Norwest Marketown Planning Proposal

LPP Response Urban Design Package — 24/05/23

Local Planning Panel Advice

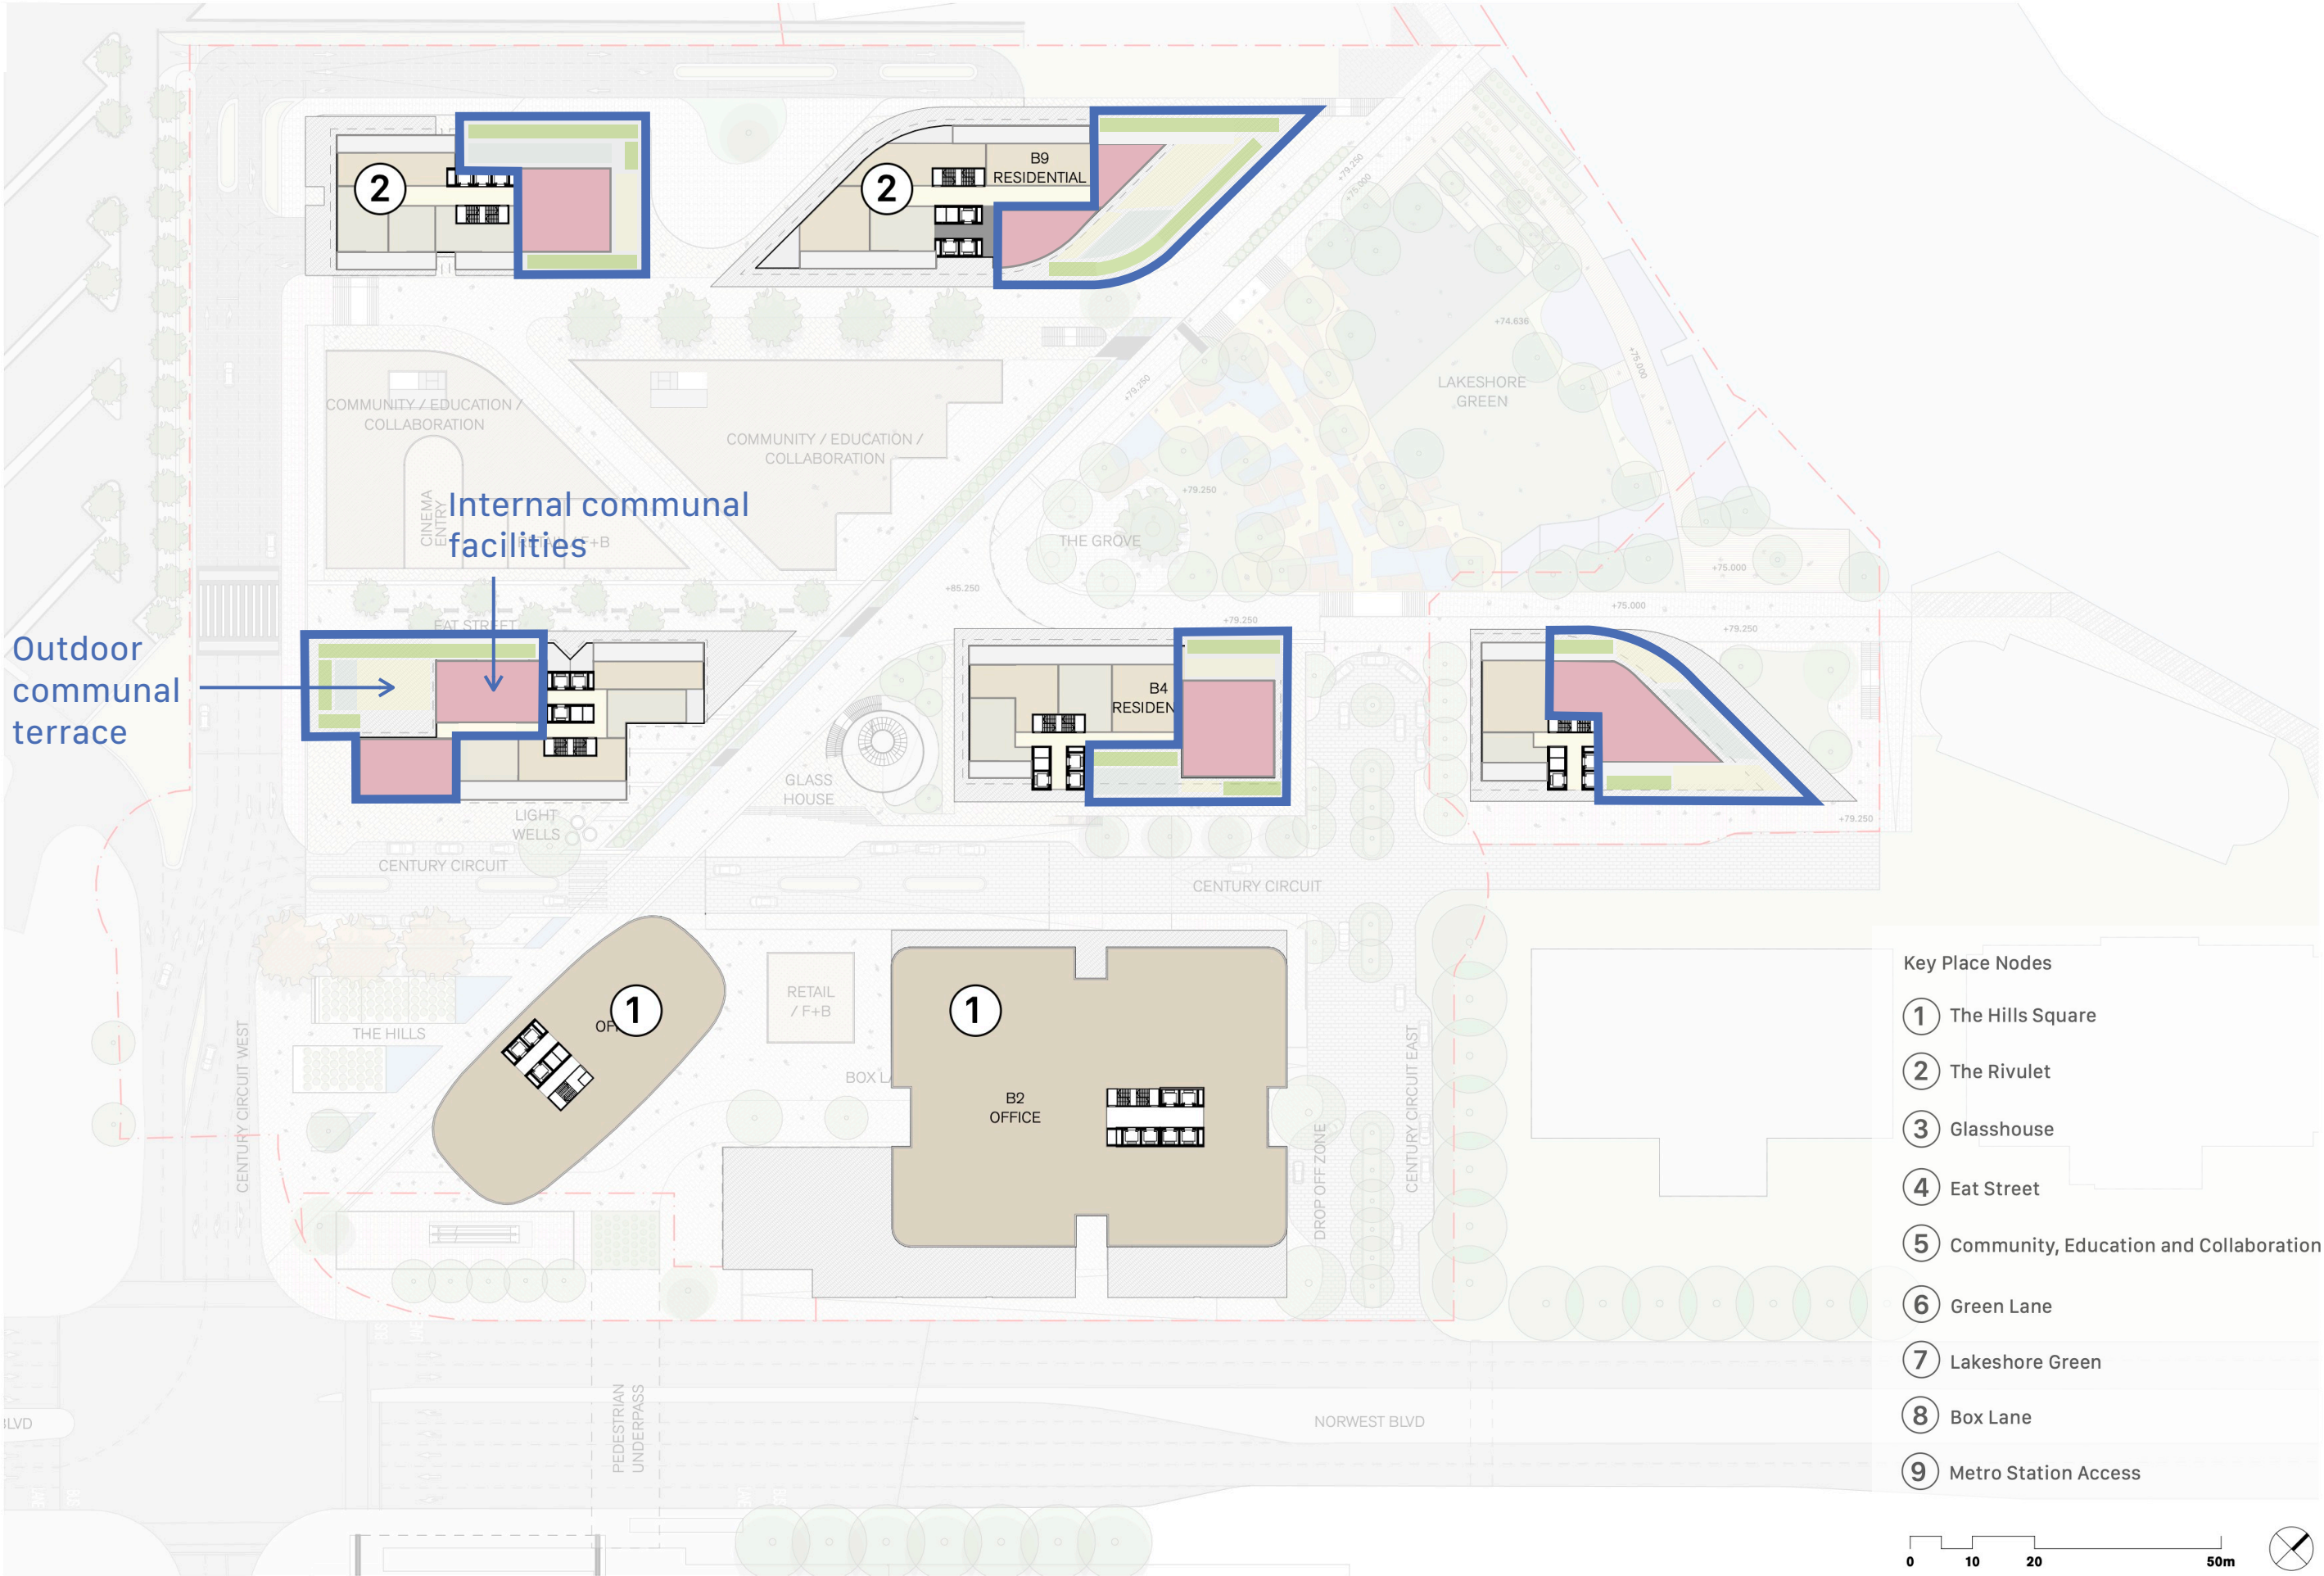
Adequate private communal open space to service residential development, separate to the proposed publicly accessible open space;

Norwest Marketown will provide a generous and high quality open space and public domain network to be enjoyed by residents, workers and visitors.

In addition, residents will have access to communal facilities to be provided in each building containing apartments. Typically communal facilities will be accommodated at podium roof level where, taking advantages of setbacks, landscape external areas and internal shared facilities can be co-located.

The diagram opposite identifies potential locations in each residential or mixed use tower for communal facilities.

-  Indicative zone for indoor and outdoor communal facilities at podium roof level
-  Indoor communal facilities such as common room and kitchen
-  Outdoor communal facilities such as bbq and seating areas
-  Indicative landscape planting

21st June 9am

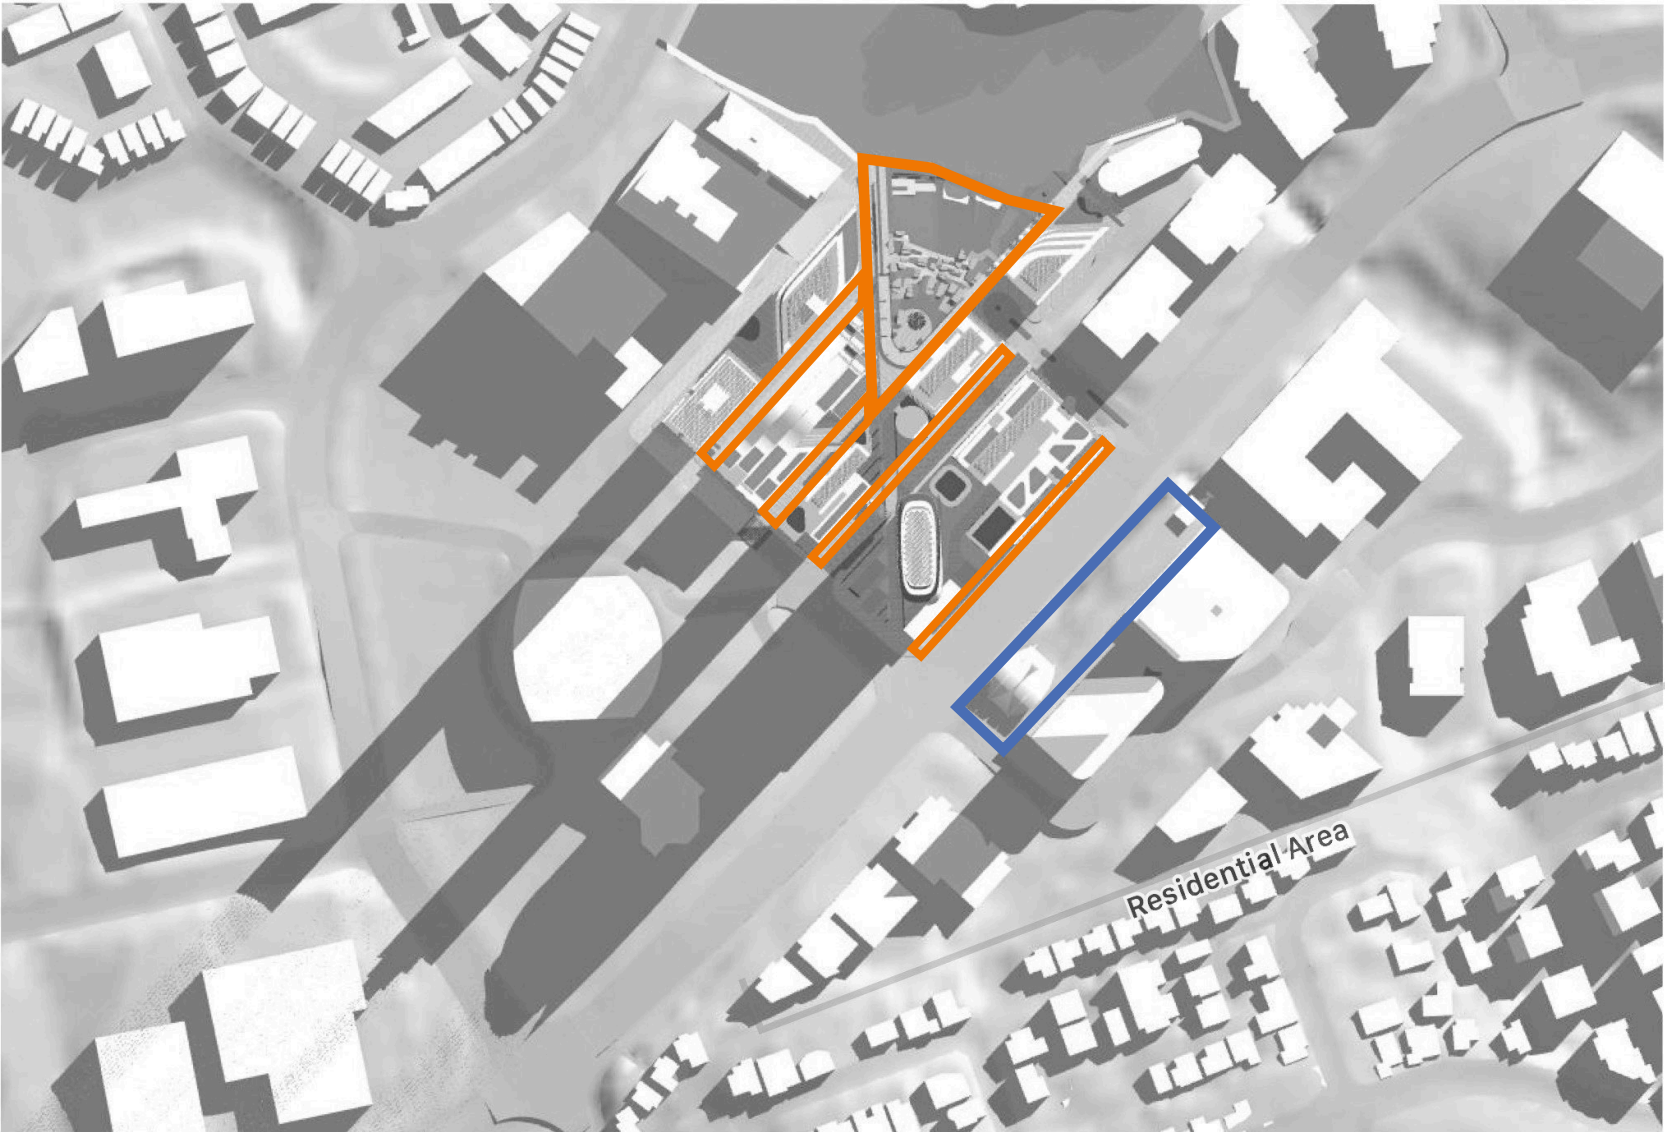
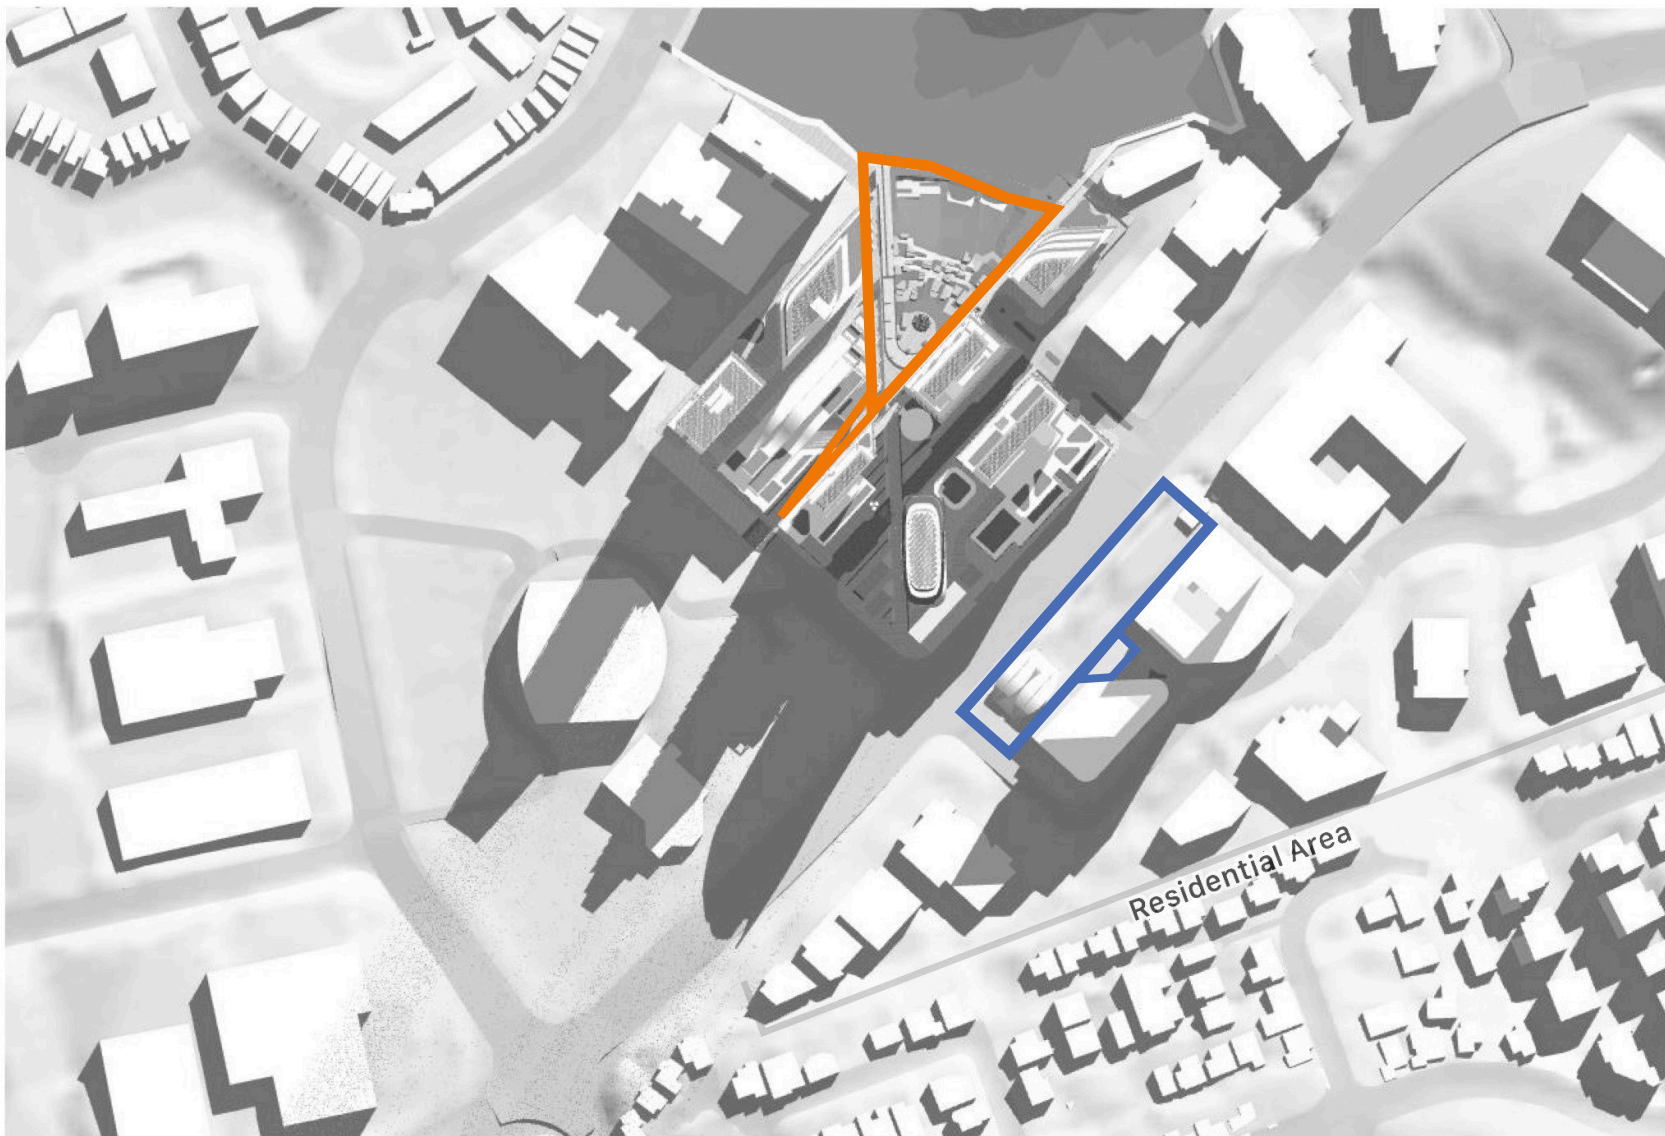
Adequate solar access to Norwest Station Site, communal open space and public domain areas at the ground plane;

The proposed built form envelopes for Norwest Marketown are arranged to optimise solar access to public open space, public domain areas and Norwest Station.

The primary open space (Lakeshore Green), pedestrian lanes and Norwest Station arrival portal & plaza all receive extensive sunlight between 9am and 10am on 21 June.

For Norwest Station, the morning peak patrons are afforded generous sunlight outside the station and into the station hall through the roof skylights.

The morning sunlight into Eat Street, particularly from 8am to 10am, will make this a popular spot to pick up a coffee or breakfast at the start of the day.
